RE: NRC Docket 40-06563,
License STB – 401
License Amendment to Remove URO from Plant 6W – Response to RAIs and
Removal of Burial Pit #10

This letter submits a final response for additional information (RAI) concerning the License Amendment to remove URO from Plant 6W and a request to include Burial Pit #10 in the License Amendment request.

NRC RAI CONCERNING THE TECHNICAL BASIS FOR MAXIMUM ACCEPTABLE SURFACE CONTAMINATION

Figure 1. Uranium-to-Thorium Ratio in URO and Adjacent Soil in Plant 6W

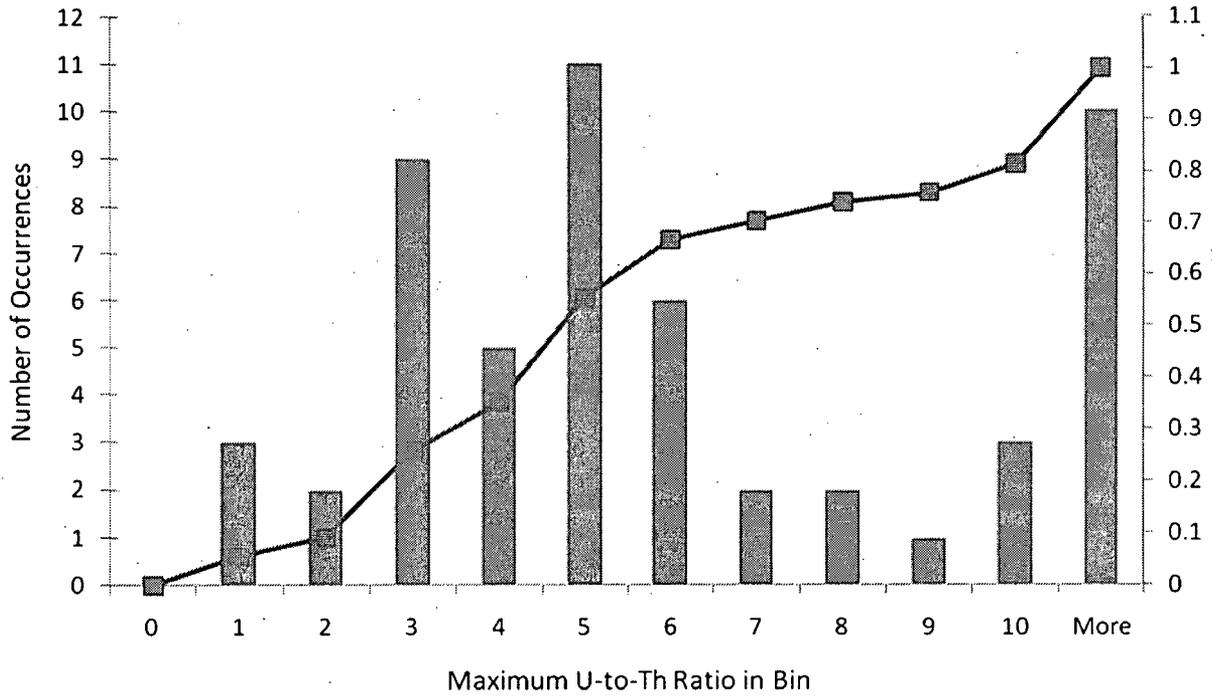
Please provide the bases for the surface contamination Derived Concentration Guideline Level (DCGL) for equipment release surveys in Table 6-4. The license amendment request proposes 2400 dpm/100 cm². Mallinckrodt should explain the basis for 2400 dpm/100 cm² or to demonstrate (by RESRAD-BUILD, etc.) that 2400 dpm/100 cm² will not exceed the applicable dose criteria.

More recent measurements of U series and Th series in URO and in adjacent soil in Plant 6W were proposed as bases of a derivation of maximum acceptable areal contamination on equipment associated with the URO project and subject to removal from Plant 6W. The uranium-to-thorium ratio and the U²³⁸-to-Th²³² ratio in each sample were calculated. An histogram of the distribution of U_{nat}-to-Th_{nat} is Figure 1 and of U²³⁸-to-Th²³² is in Figure 2 herewith. In these histograms, U-to-Th ratios in URO and adjacent soil samples were combined into one population; for the numbers of samples are roughly proportionate to the amount of URO and adjacent soil to be excavated and thus to the potential contamination by either URO or adjacent soil, or a mixture of the two.

Three or four of the samples exhibit U_{nat}-to-Th_{nat} or U²³⁸-to-Th²³² ratio less than one and those were of URO. However, the histograms also indicate that they comprise only about 6 or 7% of the total population of samples. Samples exhibiting a ratio no greater than two comprise only about 10% of the total population of samples. Overall risk of equipment being contaminated by U_{nat}-to-Th_{nat} radioactivity ratio less than two is thus relatively low.
